**Public Input No. 17-NFPA 1192-2015 [Global Input]**

Public Input No. 15-NFPA 1192-2015 [Section No. 2.3]

Figure 5.2.21.2 Appliance or Appliance Compartment Warning Label.

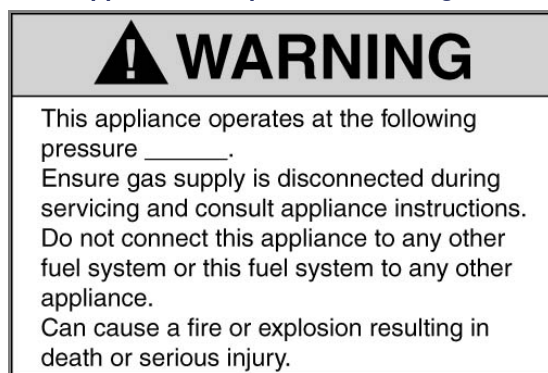
Propane appliances or fuel cells connected to regulated high-pressure piping systems shall comply with the following:

- (1) The appliance or fuel cell shall provide for a separate propane supply system or provide a means to prevent high pressure from entering the recreational vehicle's low-pressure system.
- (2) The high-pressure propane system shall be located entirely on the exterior of the vehicle or in a compartment that is vaportight to the vehicle's interior and vented to the outside at or near the bottom of compartment.
- (3) Warning labels, with the word "Warning" a minimum of ¼ in. (6 mm) high and body text a minimum of ⅛ in. (3 mm) high on contrasting background, shall be affixed to the appliance or appliance compartment and at the propane source in a visible location and shall read as shown in [Figure 5.2.21.2](#)

The warning information contained in this label is needed when the appliance is being serviced and therefore should be located at the appliance or appliance compartment. Requiring this label to be located at the propane source is unnecessary.

Figure 6.3.4 Smoke- ~~1.5~~ Smoke Alarm Warning Label.

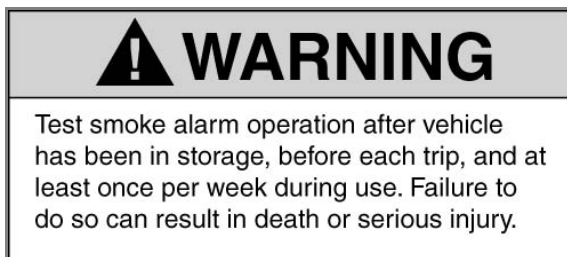
6.3.4 – ~~1.5~~ Operational Check Warning Label.

A warning label with the word "Warning" a minimum of ¼ in. (6 mm) high and body text a minimum of ⅛ in. (3 mm) high on a contrasting background shall be affixed in a visible location on or within 24 in. (610 mm) of the smoke alarm and shall read as shown in [Figure 6.3.4](#).

Figure 7.4.4.12 Waterless Trap Notice Label.

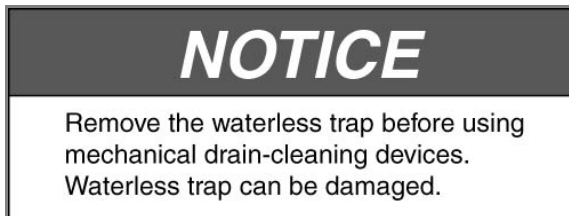
A waterless trap shall have affixed on or adjacent to it or the fixture it services a label with the word "NOTICE" with letters a minimum of ¼ in. (6 mm) high and body text a minimum of ⅛ in. (3 mm) high on a contrasting background that shall read as shown in [Figure 7.4.4.12](#).

Revise the text. In many cases a location adjacent to the waterless trap or the sink it services is more visible. The label should be permitted on or adjacent the sink the waterless trap services as this is where the cleanout tool could be inserted.
